SUBJECT: Transmittal of Revised Responses to AP1000 DSER Open Items

**AP1000 Design Certification Review
Draft Safety Evaluation Report Open Item Non-Proprietary Responses**

DSER Open Item Number: 3.6.3.4-2 Addendum 2 Revision 1

Figure 1: MAAP4 Containment Temperature for Sequence 3BE-1

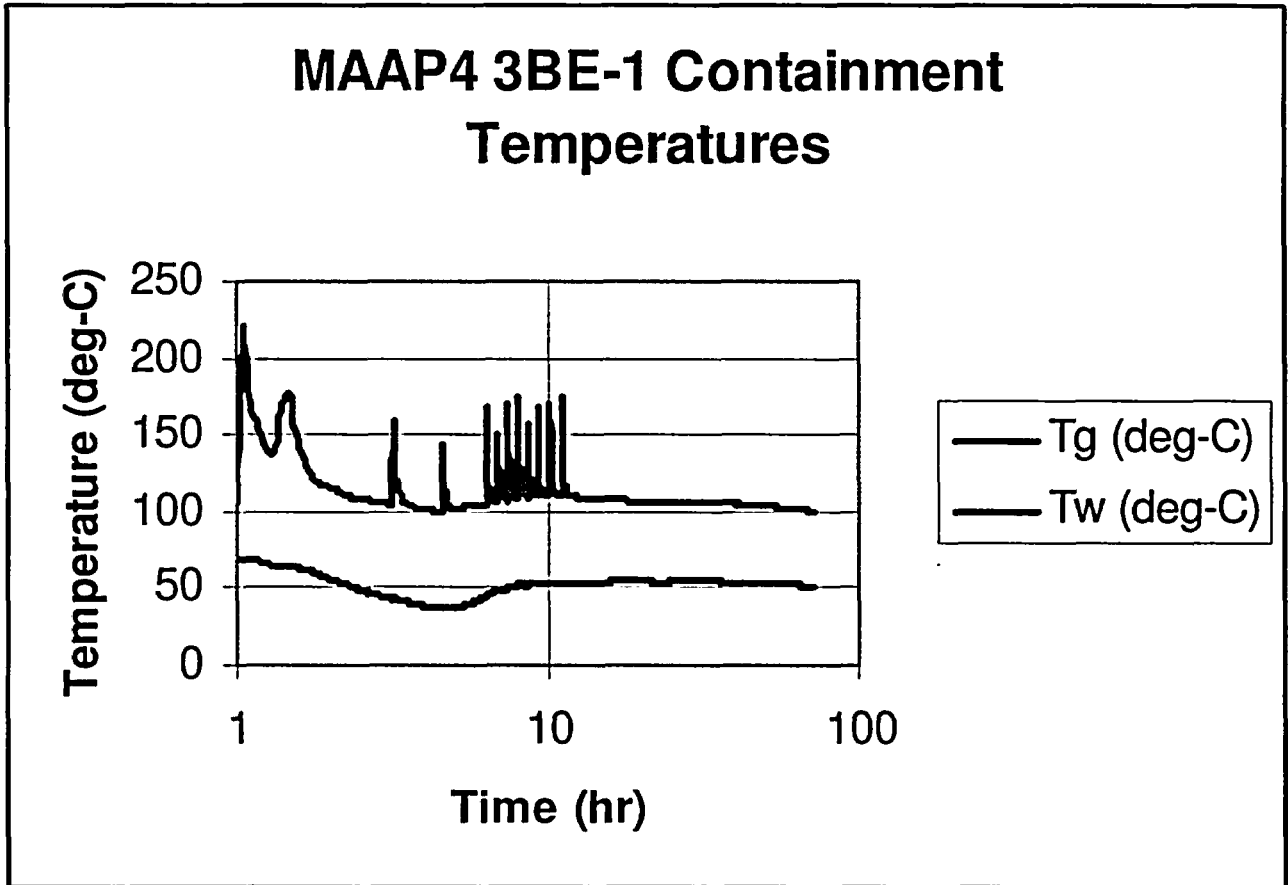
The convective and radiative heat transfer to the containment shell was determined using the results from the MAAP4 simulation of sequence 3BE-01. The containment gas temperature and the film temperature on the wall are shown in Figure 1 for this sequence. Figures 2 and 3 shows the temperature difference between the gas and the film which is the driving mechanism for heat transfer. For the first 10 hours, the temperature difference is approximately 60C, and for times after 10 hours, the temperature difference is approximately 50C. To determine the gas properties, the following temperatures are used:
